K3 KIT ASSEMBLY MANUAL ERRATA

Rev. M-4, May 1, 2015

A new synthesizer pc board is now being shipped for your K3. The following changes are required to install the new board. The new and original synthesizer boards are shown below:

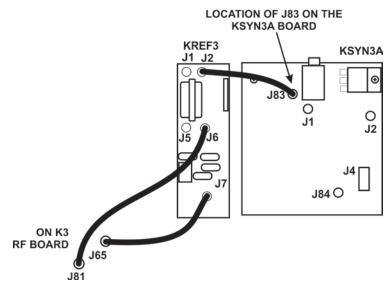
Page 54, Figure 76: The location of J83 is different on the KSYN3A board. It is closer to the KREF3 board as shown in the diagram below:
